Product/Process Change Notice (PCN)

PCN Number: PCN_IndCMBNC_20250610

Affected Series: WE-CMBNC

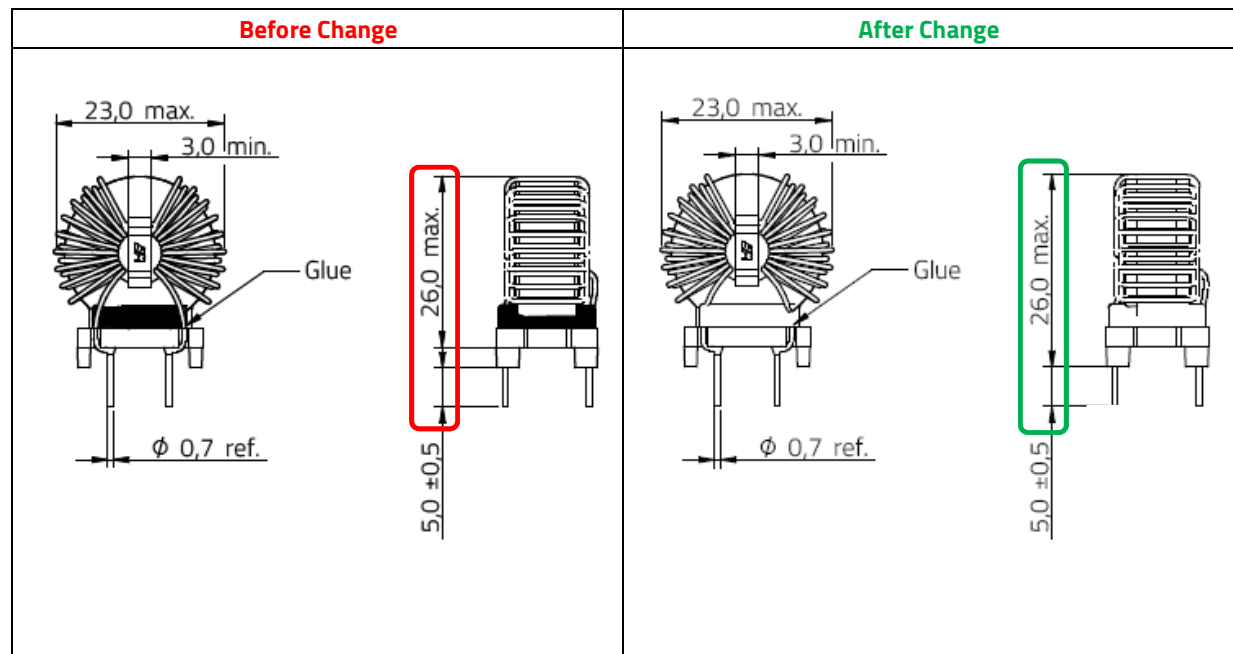
Because of a database mismatch, Würth Elektronik eiSos will correct the specified height of the affected part numbers.
